RE: Response to LUPC Comments of February 24, 2023

Jeremy Ouellette, Vice President Project Development  
WOLFDEN MT. CHASE LLC  
20 Main Street  
Patten, ME 04765

**Attachment A – Additional Mine Figures (#3)**

**Attachment B – Spray Irrigation/Snowmaking/Snow  
Storage**

Figure 1: P-SL2 Areas Map

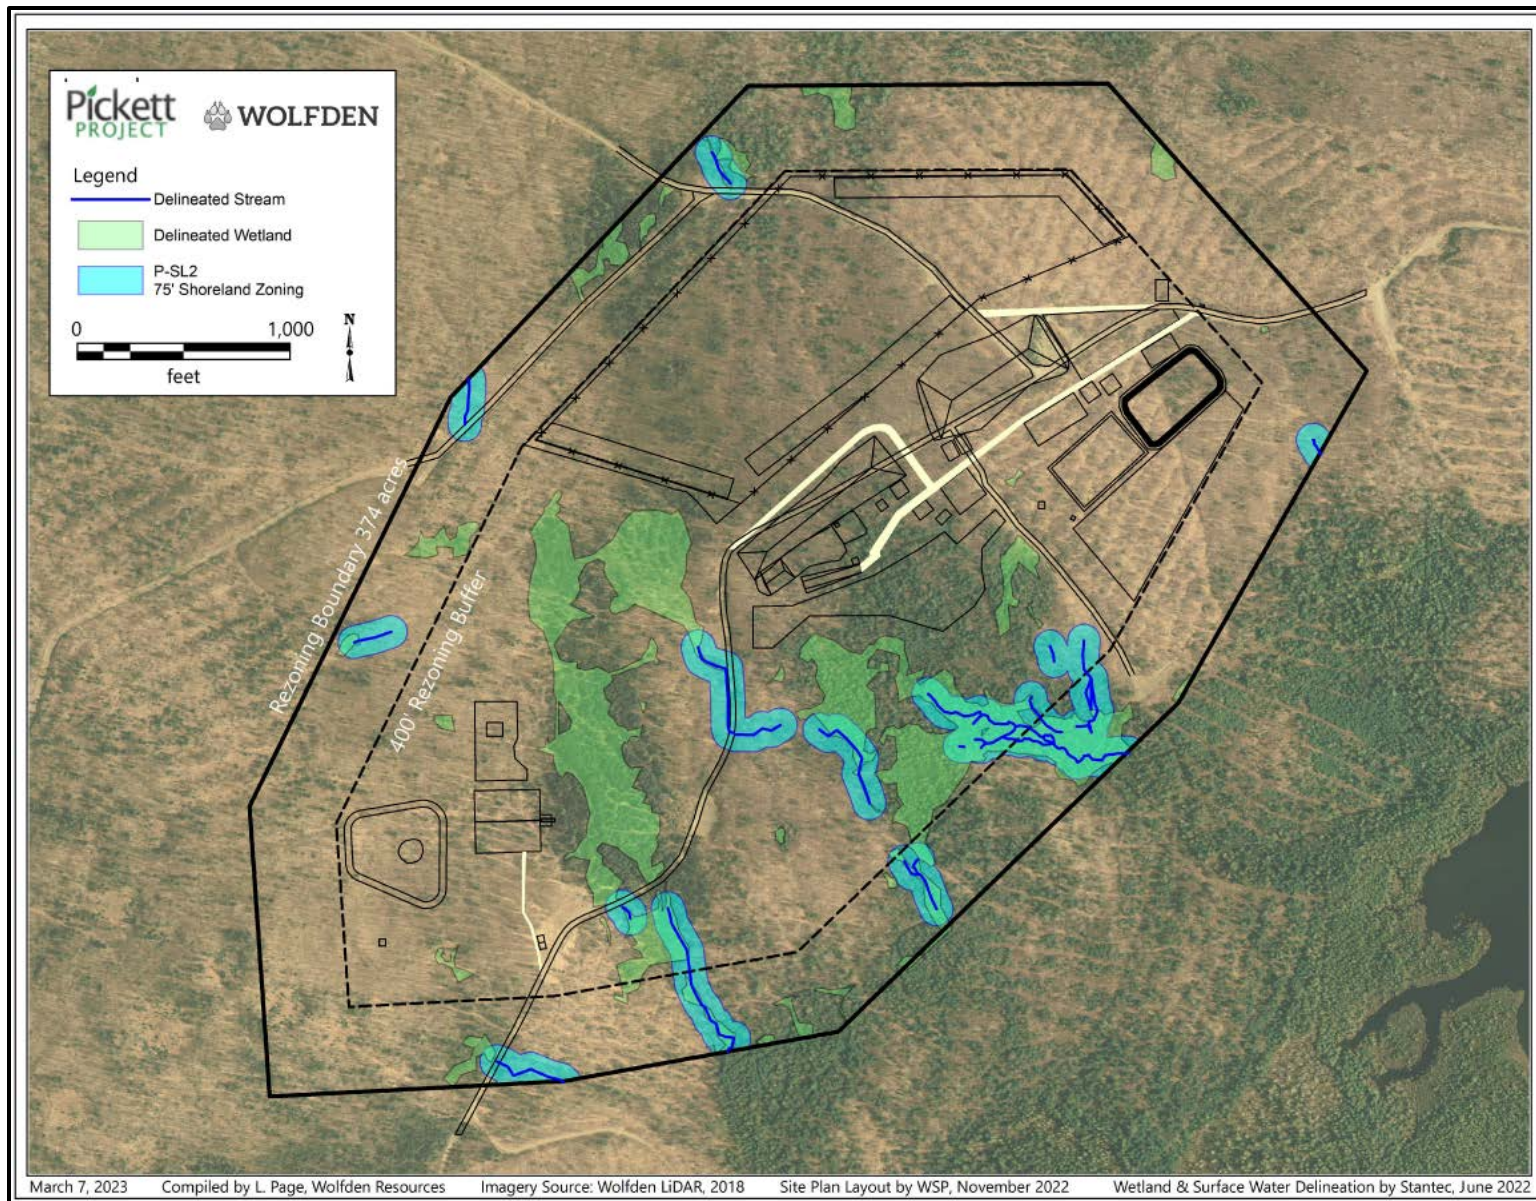
Surveys of the area to be rezoned have found intermittent streams. By rule these streams are bordered by Shoreland Protection subdistricts (P-SL2) of 75 ft. landward from the normal high-water mark on either side. Please provide a revised total acreage of General Management subdistrict (M-GN) and the total acreage of P-SL2 subdistrict that will be rezoned to the D-PD subdistrict. It is our understanding that the total area proposed for rezoning is 374 acres.

*The P-SL2 areas within the footprint represent 24 acres of the 374 rezone area as shown on Figure 1 below. This results in a General Management Subdistrict of 350 acres.*

**Figure 2: Typical Underground Shop/Service Bay/ Wash Bay**

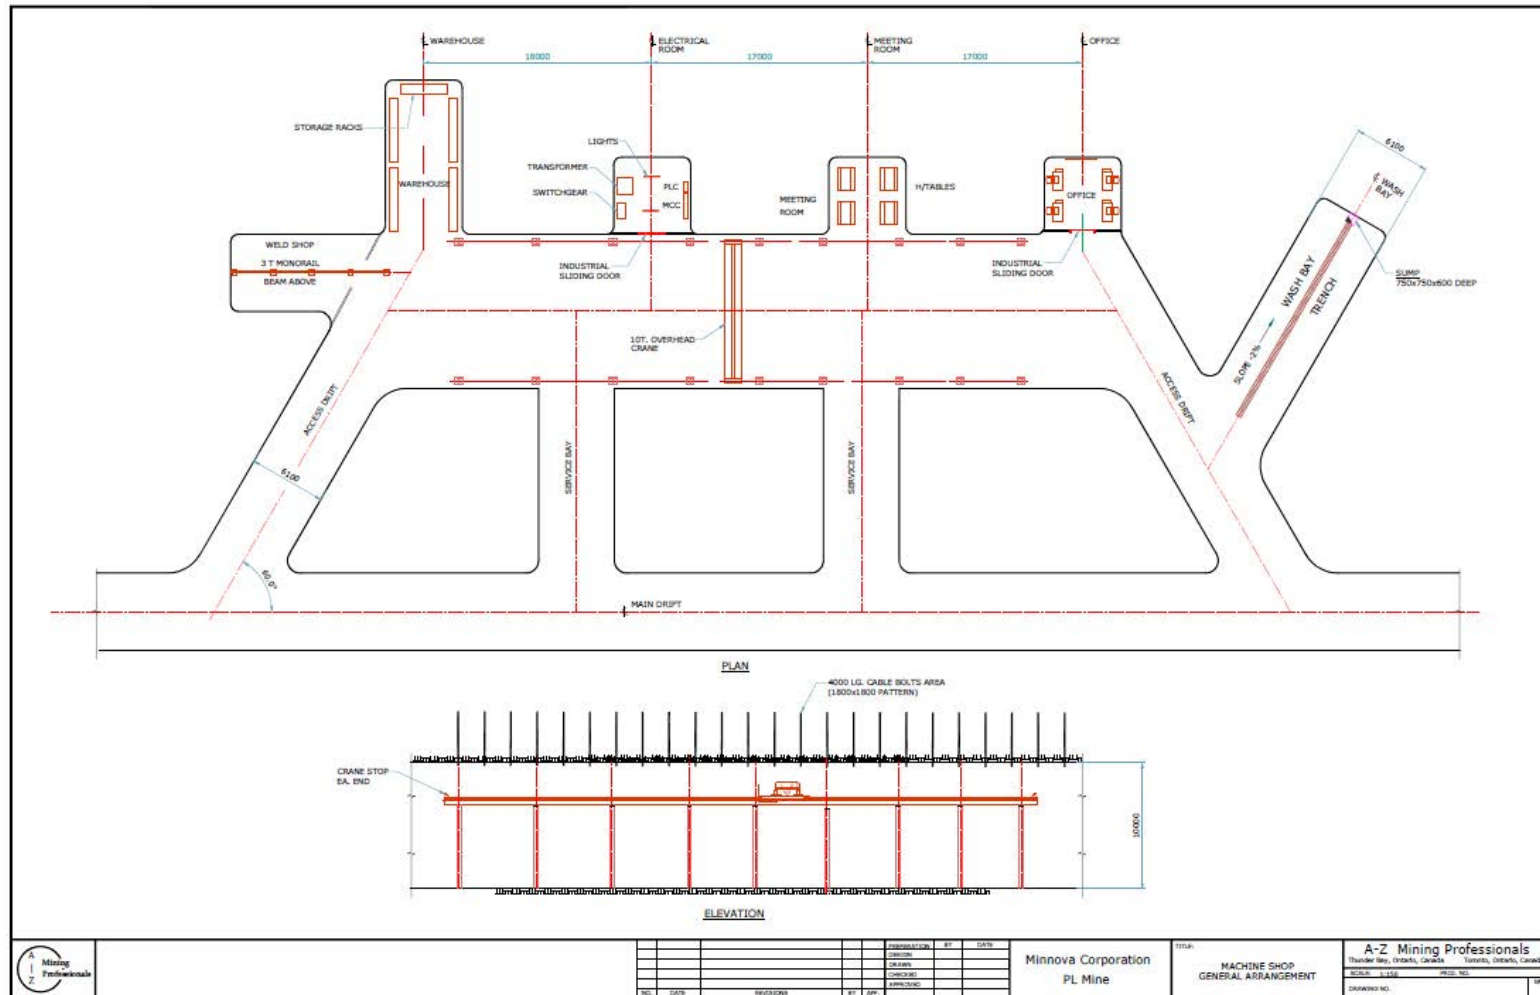
Clarify the underground facilities that are planned. The Preliminary Economic Assessment (Financial Practicability, Exhibit 14, Attachment 14-A) describes underground facilities that are not included in the Project Description (Exhibit 2): a breakdown maintenance shop, an equipment wash bay, water transfer stations and holding tanks for mine process water, and communication and control systems. Provide detailed schematics for any of these additional underground facilities that are planned.

Figure 2 is an example of an underground maintenance/breakdown shop with an attached wash bay. This is typical of underground workings and allows space for maintenance team offices, vehicle washing prior to/during breakdown and maintenance activities, as well as parts and supplies storage.

**FIGURE 1**  
**PRE-DEVELOPMENT**  
**WETLAND CATCHMENTS**  
**WOLF DEN RESOURCE CORPORATION**  
**PICKETT MOUNTAIN MINE SITE**  
**T6 R6, MAINE**

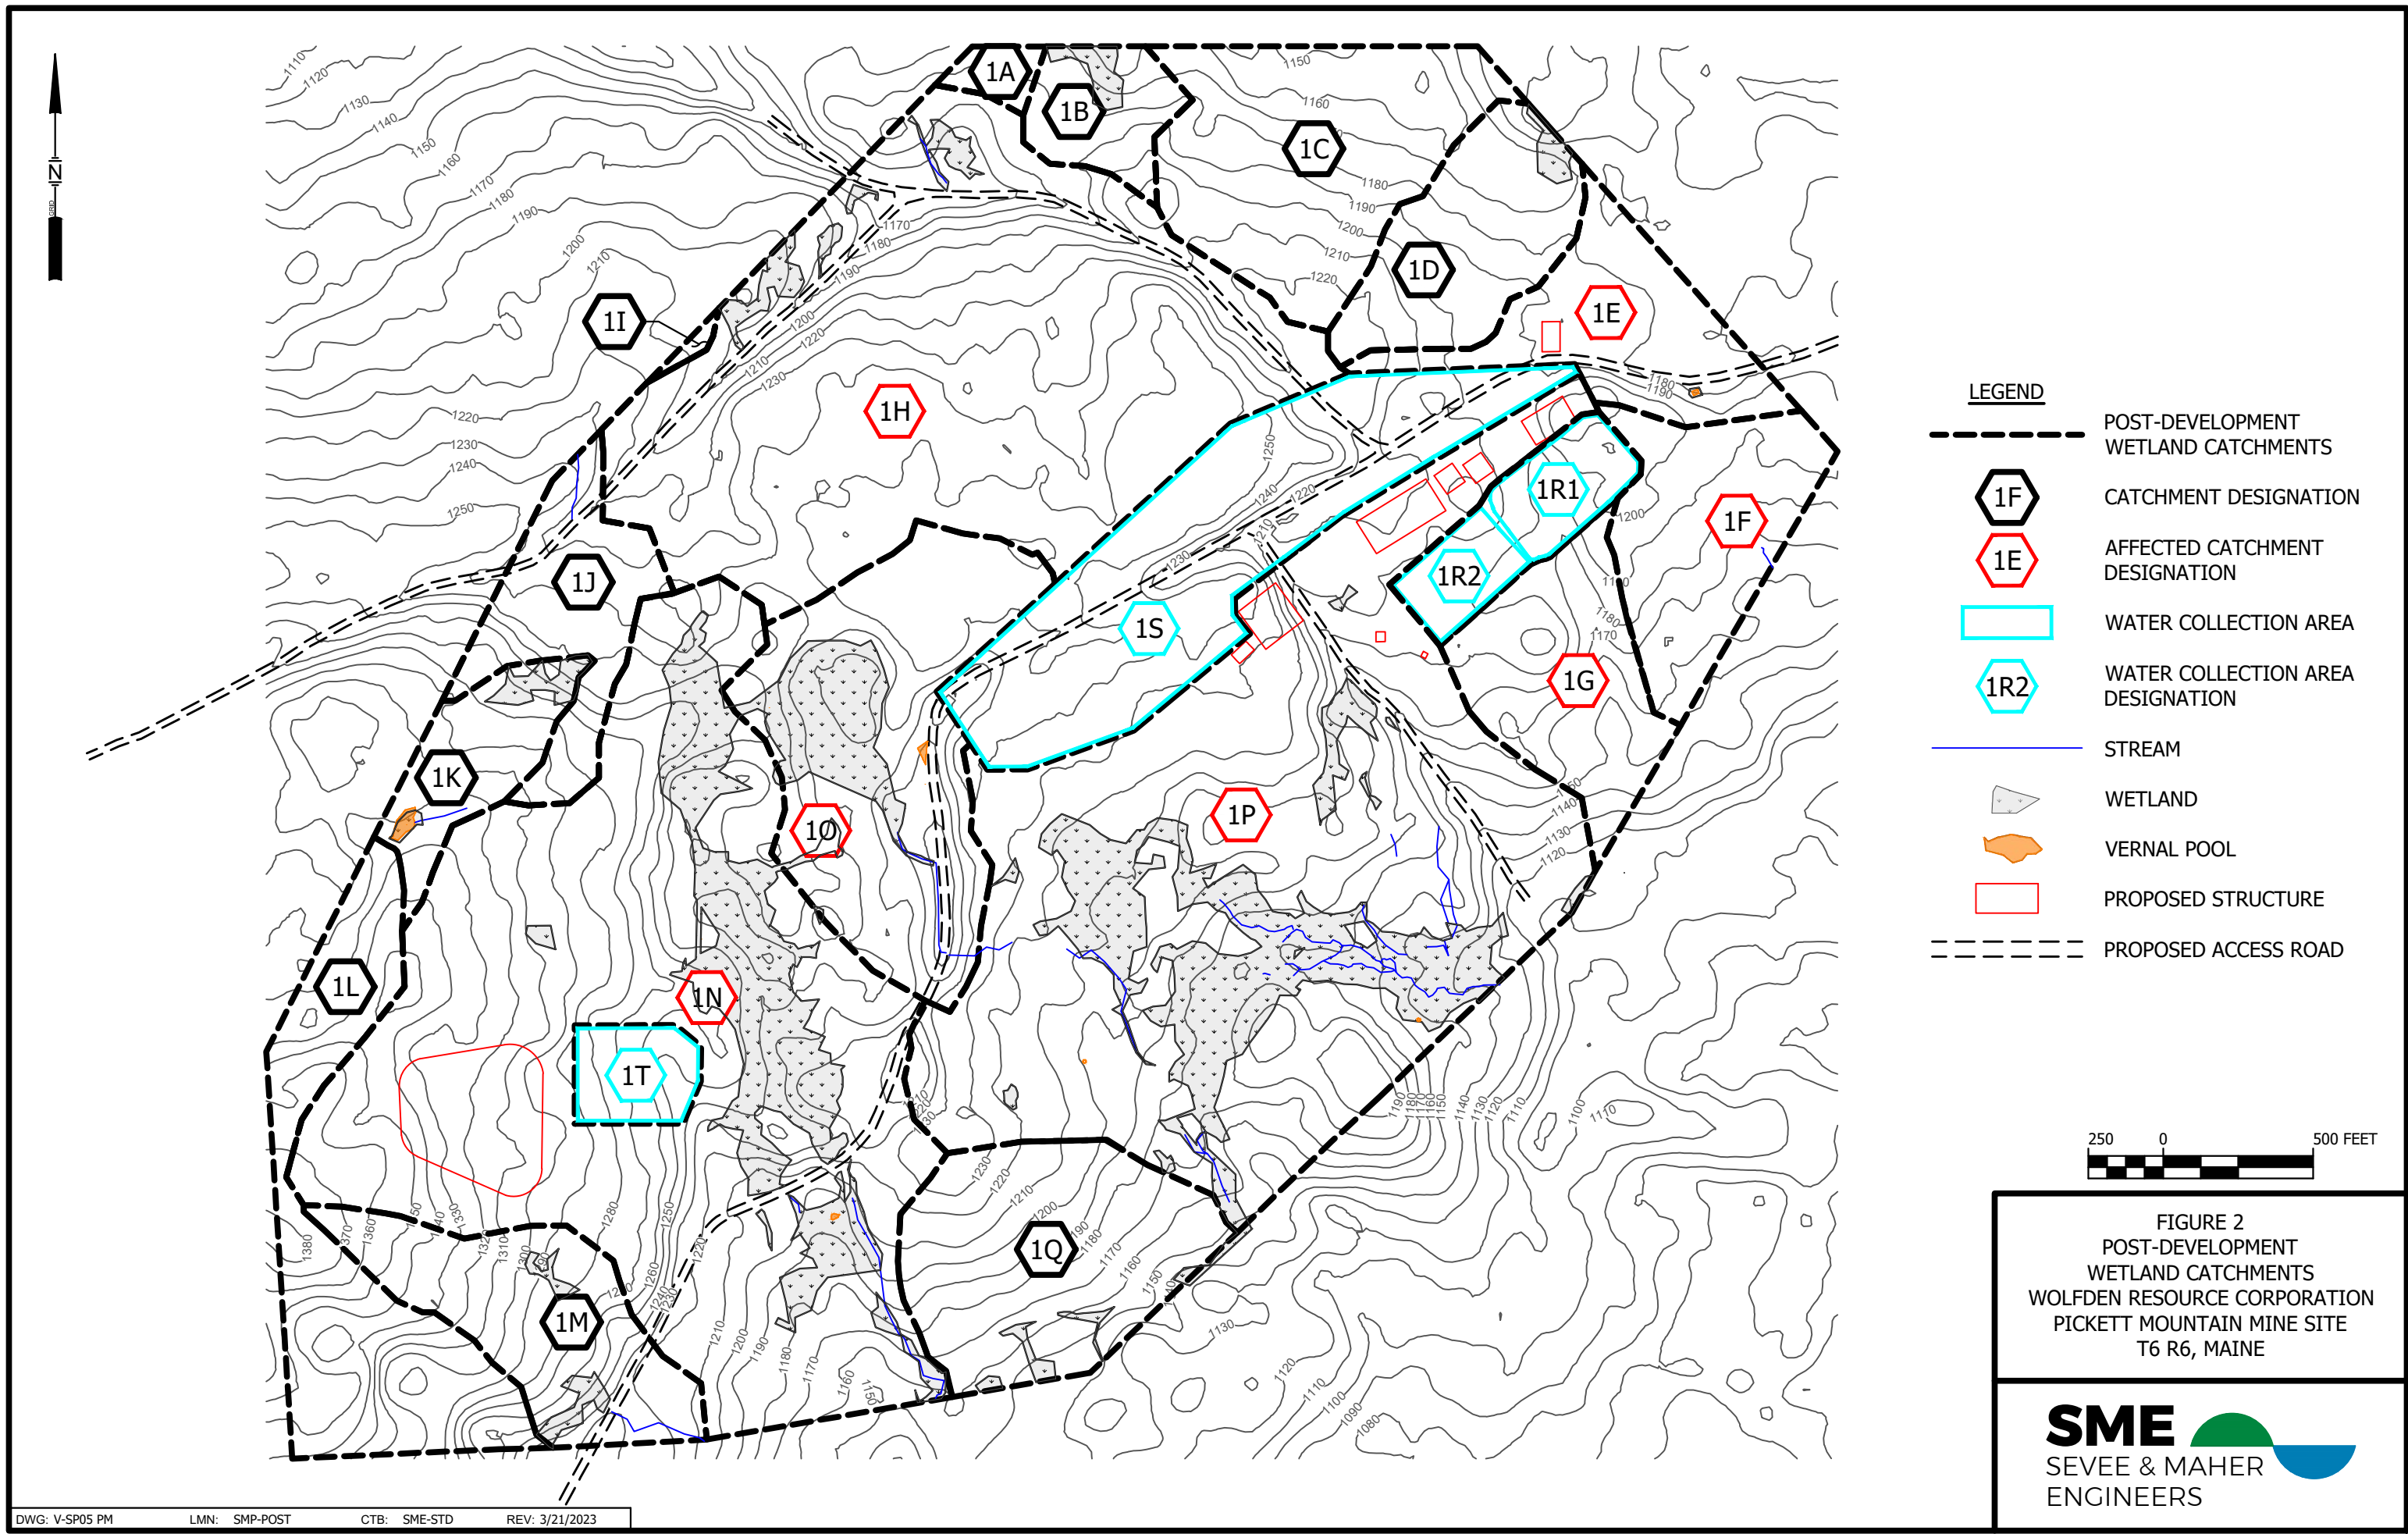
The application does not include a sufficient demonstration that the discharge of collected storm and mine waters would have no undue adverse impact on downgradient wetland and stream hydrology, especially considering the timing and quantity of water flows. If any wetland or flowing water will receive more or less water than pre-development, provide evidence to demonstrate that there will not be undue adverse impacts on those habitats or the species depending on those habitats. Consider if water would be diverted from one subcatchment area to another and that water from mine shaft dewatering may not have reached the streams pre-development and therefore will be a source of additional volume.

Sevee & Maher Engineers, Inc. (SME) used an average precipitation value of 45 inches per year (Wood, Technical Memorandum to Wolfden, revised August 25, 2022) to calculate a total average precipitation inflow of approximately 456 million gallons per year (MGY) for the 374-acre site. LIDAR topography was reviewed relative to the wetland areas on and immediately adjacent to the site, and seventeen separate wetland catchments were identified for the pre-development condition. These wetland catchments are depicted on Figure 1.
